Addendum No. 1 **February 14, 2017**

Project: **Lansing Pathway Promise**
Project: SB-0006
Fairview Additions and Renovations

ADDENDUM #1

Project No.:	16-0400	**Date:**	February 14, 2017
Project:	Lansing Pathway Promise SB-0006 Fairview Additions and Renovations Ingham County, Michigan	**A/E Firm:** **Project Manager:**	C2AE Steve Jurczuk
Owner:	Lansing School District 519 West Kalamazoo Street Lansing, MI 48933

SCALE: As indicated
PROJ. #: 160406
DATE: 01/13/2017
SHEET: A-201
ADDENDUM 1

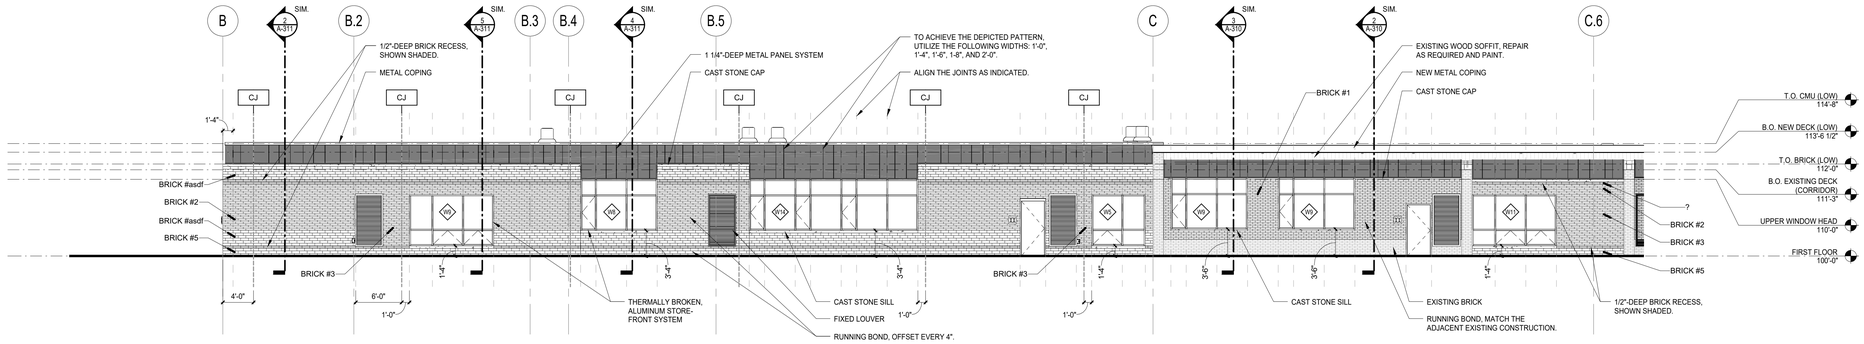
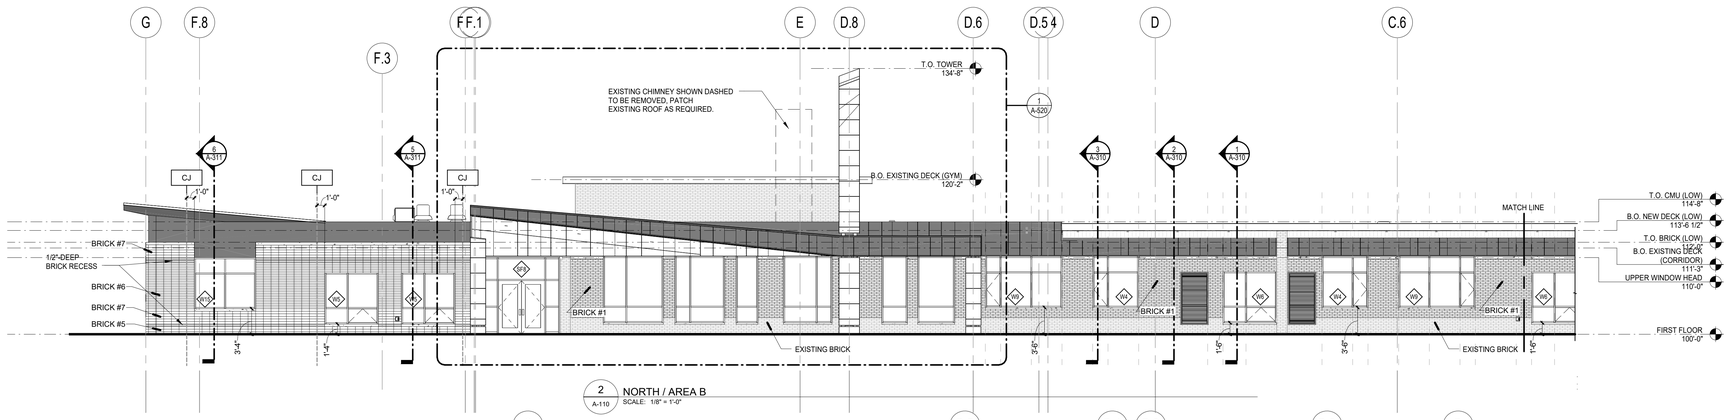
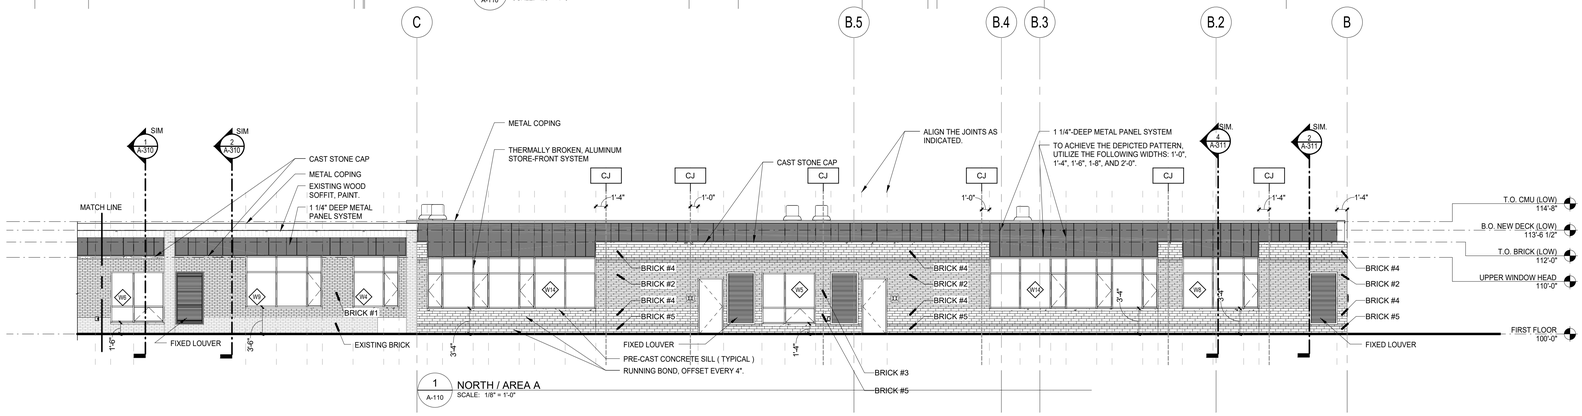
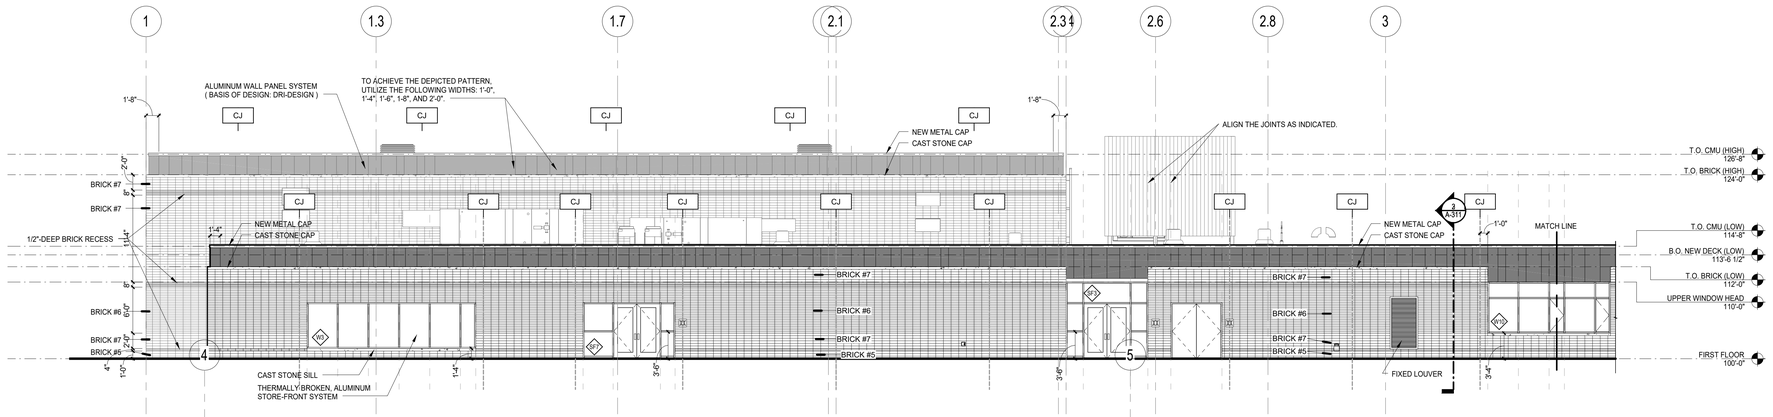
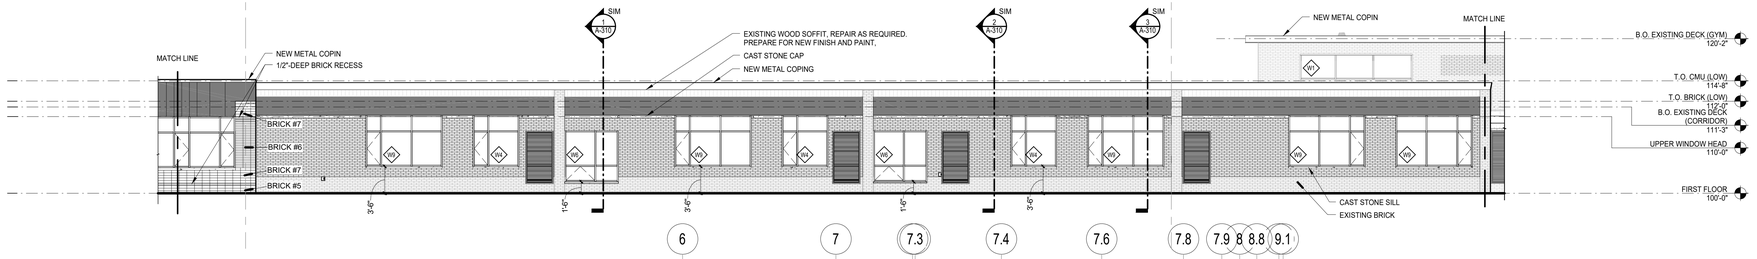
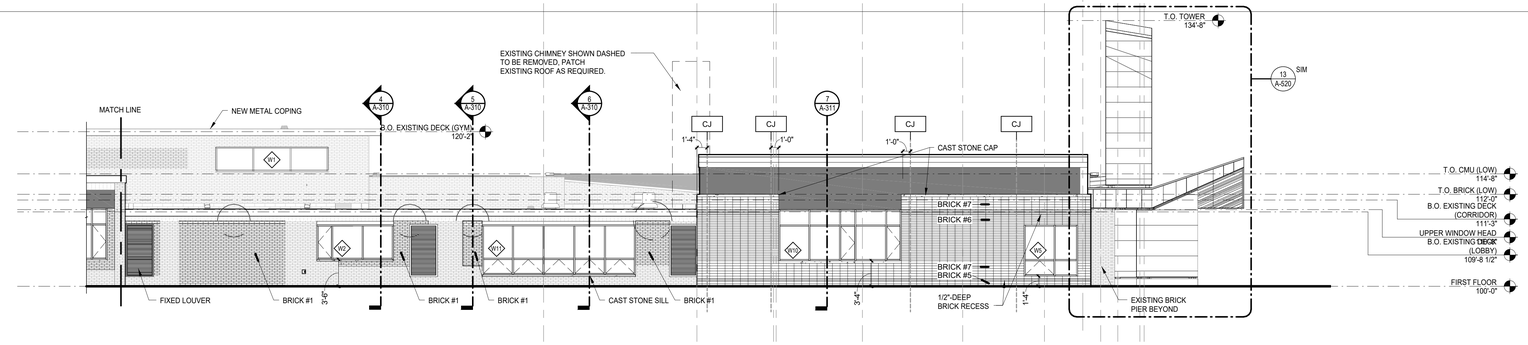
A1.25 Refer to Sheets A-200, A-201, A-202, and A-203 (reissued):
See revised exterior elevations with additional notes.

4 GROUP RESTROOMS
A-110.E SCALE: 1/4" = 1'-0"

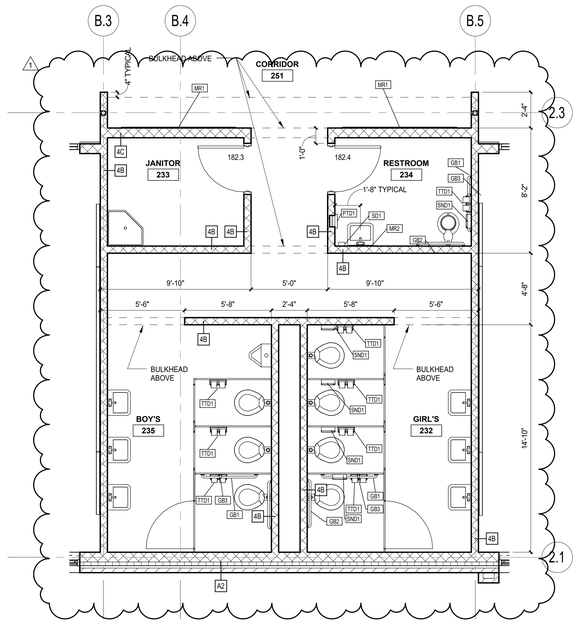
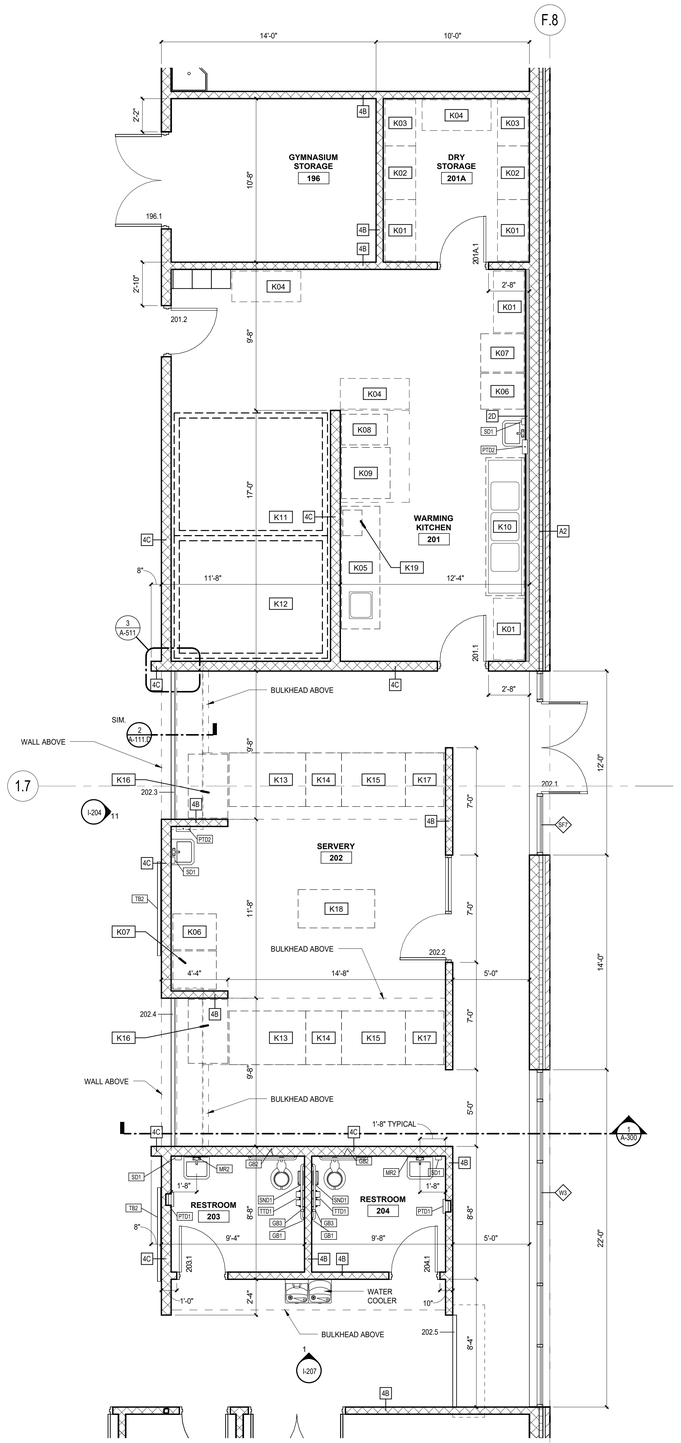
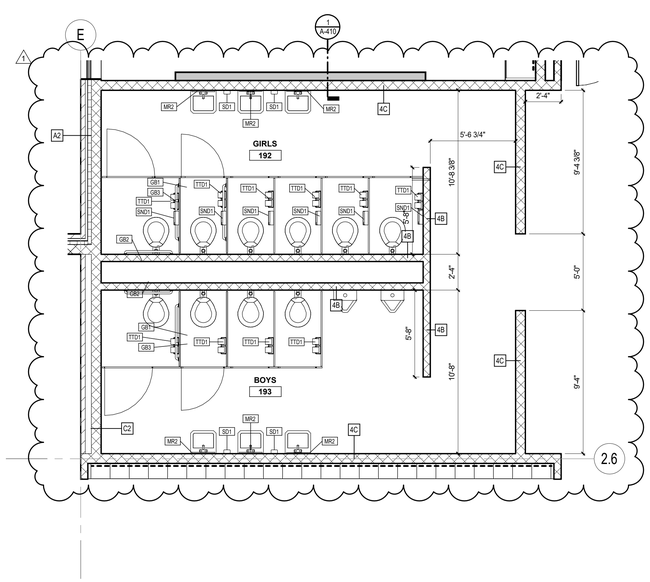
A1.20 Refer to Sheets A-110B, A-110D, A-110E and A-401 (reissued):
REVISE group restrooms as shown.

SCALE:
PROJ # 160400
DATE 02/13/2017
SHEET P-900

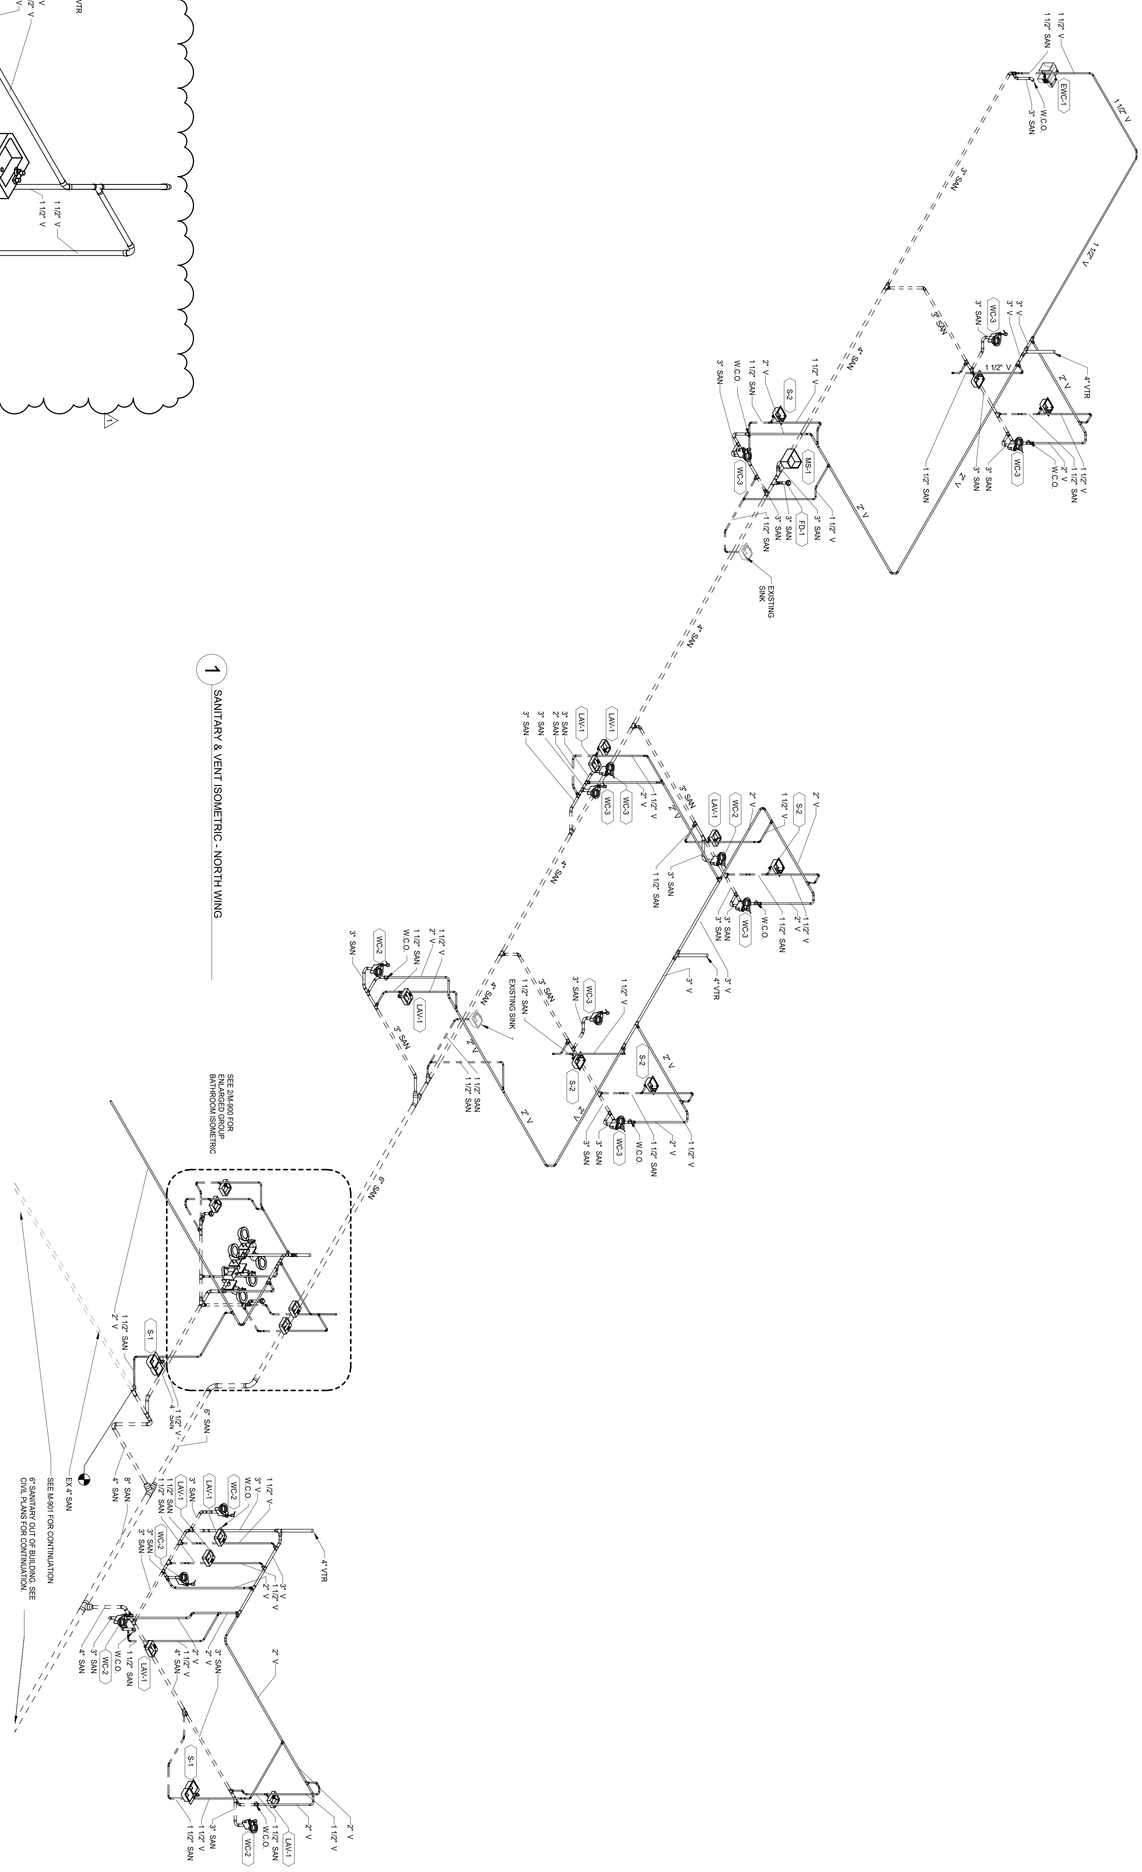
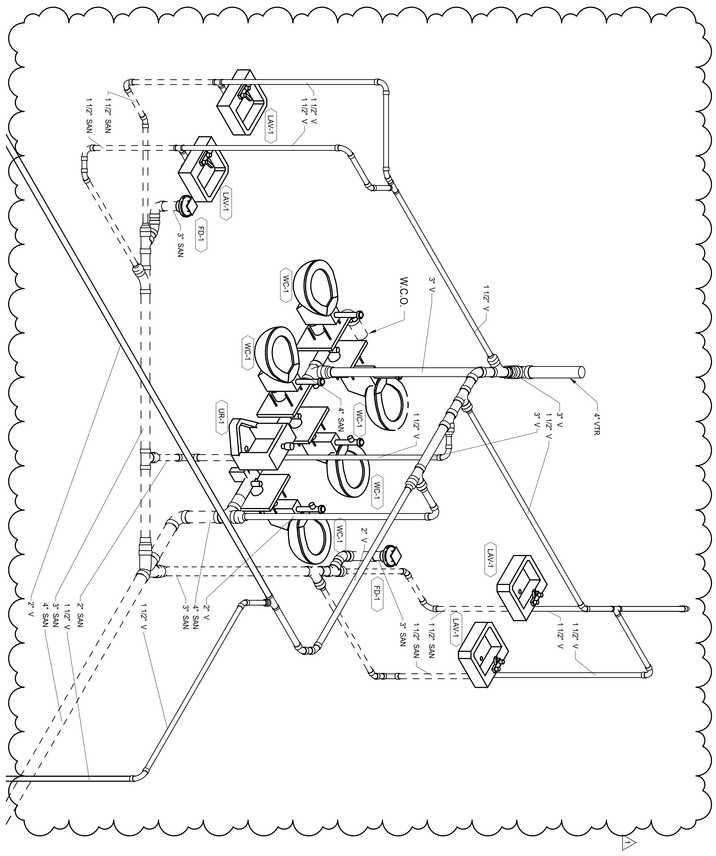
A1.37 Refer to Sheet P-900 (reissued):
REVISE sanitary piping isometric for new bathroom fixture layout as shown.
